Well Name: WELLER 21 16 FEDERAL COM	Well Location: T25S / R27E / SEC 21 / NWSE / 32.112118 / -104.194767	County or Parish/State: EDDY / NM
Well Number: 276H	Type of Well: OIL WELL	Allottee or Tribe Name:
Lease Number: NMNM107369	Unit or CA Name: WHITE CITY 21 25 27 FED COM 5H	Unit or CA Number: NMNM135707
US Well Number: 3001556280	Operator: CHEVRON USA INCORPORATED

Notice of Intent

Type of Action: APD Change

Procedure Description: CHEVRON USA, INC. REQUESTS THE FOLLOWING: WELLER 21 16 FEDERAL COM 276H / API # 30-015-56280 CHEVRON REQUESTS TO MOVE THE WELL FROM THE E/2 E/2 OF SECTIONS 21&16 TO THE W/2 E/2 OF SECTIONS 21&16 (PLEASE SEE ATTACHED C-102'S AND DIRECTIONAL DRILLING SURVEY) CHEVRON REQUESTS TO CHANGE THE WELLER 21 16 FEDERAL COM 276H FROM INFILL WELL TO DEFINING WELL CHEVRON REQUESTS TO CHANGE THE DRILLING DESIGN FROM FOUR-STRING DESIGN TO THREE-STRING DESIGN (PLEASE SEE ATTACHED REVISED 9-POINT)

T:\2023\2236832\DWG\Weller 21 16 Federal Com 276H C-102(Sec. 21).dwg

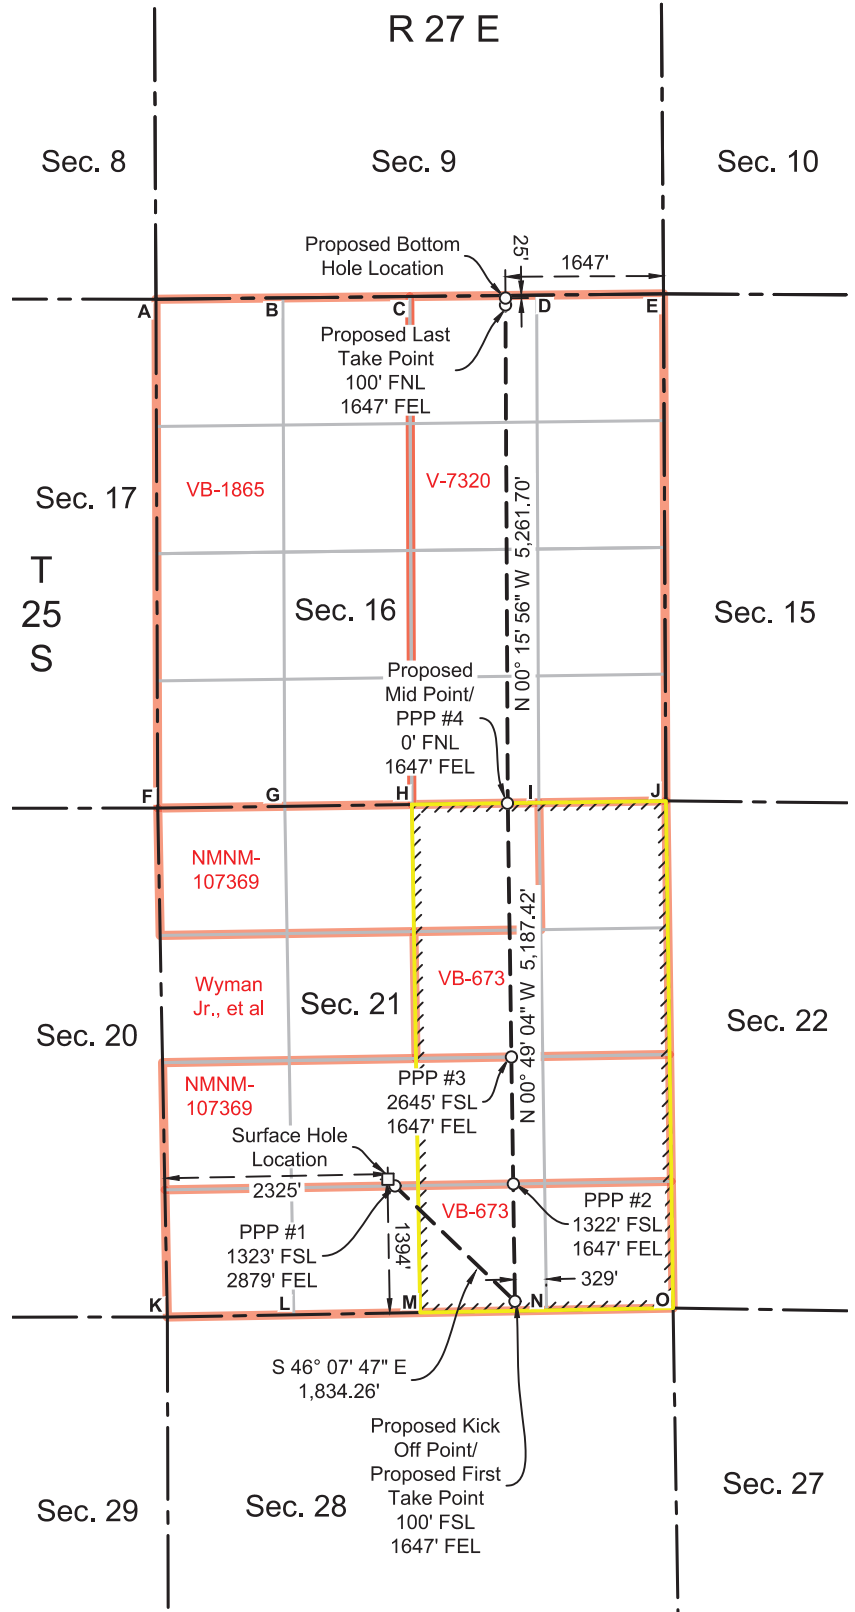
WELLER 21 16 FEDERAL COM 276H / API # 30-015-56280
 CHEVRON REQUESTS TO MOVE THE WELL FROM THE E/2 E/2 OF SECTIONS 21&16 TO THE W/2 E/2 OF SECTIONS 21&16
 (PLEASE SEE ATTACHED C-102'S AND DIRECTIONAL DRILLING SURVEY)
 CHEVRON REQUESTS TO CHANGE THE WELLER 21 16 FEDERAL COM 276H FROM INFILL WELL TO DEFINING WELL
 CHEVRON REQUESTS TO CHANGE THE DRILLING DESIGN FROM FOUR-STRING DESIGN TO THREE-STRING DESIGN
 (PLEASE SEE ATTACHED REVISED 9-POINT)

UL K	Section 21	Township 25 SOUTH	Range 27 EAST, N.M.P.M.	Lot N/A	Ft. from N/S 1394' SOUTH	Ft. from E/W 2325' WEST	Latitude 32.112101° N	Longitude 104.196082° W	County EDDY
------	------------	-------------------	-------------------------	---------	--------------------------	-------------------------	-----------------------	-------------------------	-------------

UL B	Section 16	Township 25 SOUTH	Range 27 EAST, N.M.P.M.	Lot N/A	Ft. from N/S 25' NORTH	Ft. from E/W 1647' EAST	Latitude 32.137325° N	Longitude 104.192090° W	County EDDY
------	------------	-------------------	-------------------------	---------	------------------------	-------------------------	-----------------------	-------------------------	-------------
